Memorandum

To: City of Gresham City Council
From: Ray Moore, PE, PLS
Date: 5-19-25
Subject: Gresham Stormwater Management Manual Updates

Section 3.2.1 Rain Gardens and Swales

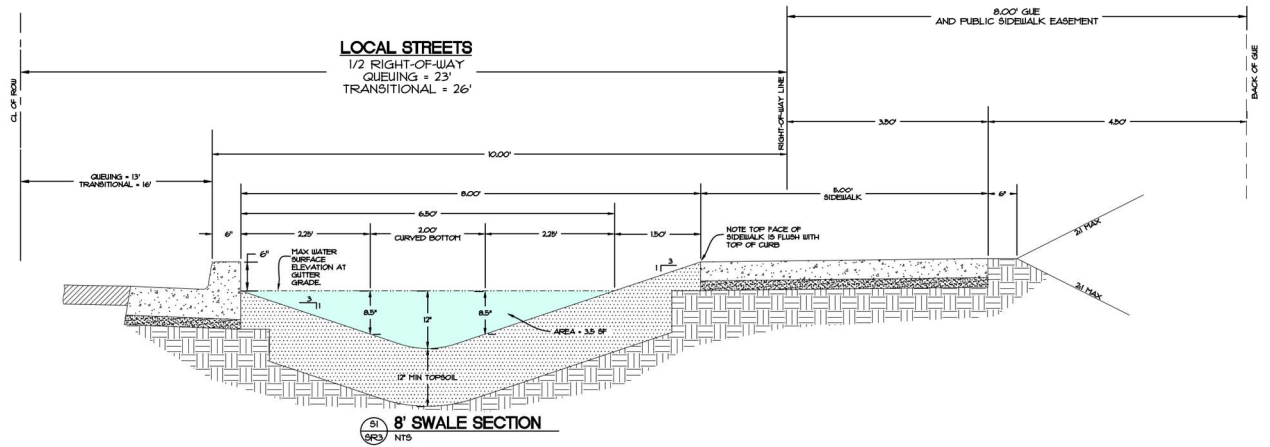
I am currently retrofitting subdivisions with 8' wide swales and can meet the water quality standards with this width. I think 10' wide swales would be overkill. I have also been placing the sidewalk in the general utility easement without making the right-of-way wider. See detail below. The swales are typically on streets that do not have driveways, so there is room to place the sidewalk in the easement without interfering with driveways. The current draft detail GS-115 shows a 10' swale between the sidewalk and the curb, the current code requires a minimum of 4'. This is an increase of 6' on each side of the street. So, the typical queuing street right of way will go from 46' to 58'. It is also my understanding that all street rights-of-ways will become wider with or without the installation of swales. This increase in right-of-way width will reduce densities. See the "Lot Layout Sketch Map" below. This is a rough map laying out 5,000 sf lots under the existing street widths and comparing them to the new right-of-way widths based on 10' wide swales. As you can see there is a 12.5% reduction in lots (8 lots removed). If the lots sold for \$150,000 each, this is a loss of \$1,200,000 just in land value. I recommend the following 1) Make the minimum width for new swales to be 8'. 2) Allow the sidewalks to be in an easement.

LOT LAYOUT SKETCH MAP

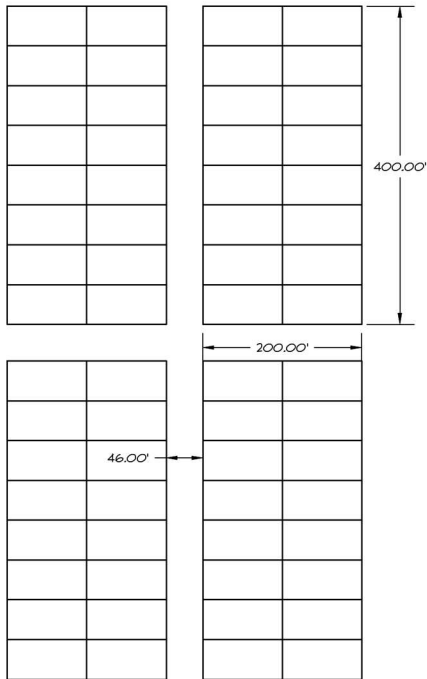
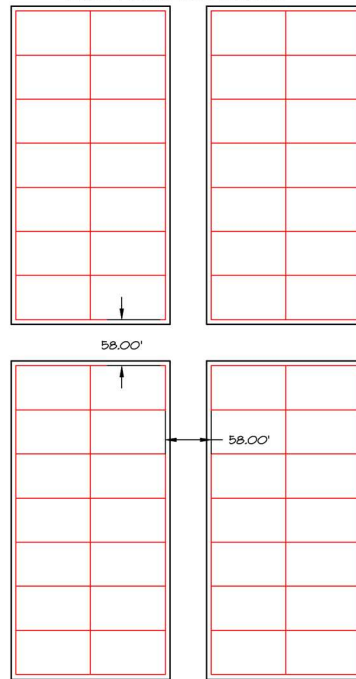
LAYOUT A WITH 8' SWALES IN EASEMENTS
TOTAL LOTS = 64 LOTS

LAYOUT B WITH 10' SWALES IN ROW
TOTAL LOTS = 56 LOTS
(12.5% REDUCTION IN LOTS)
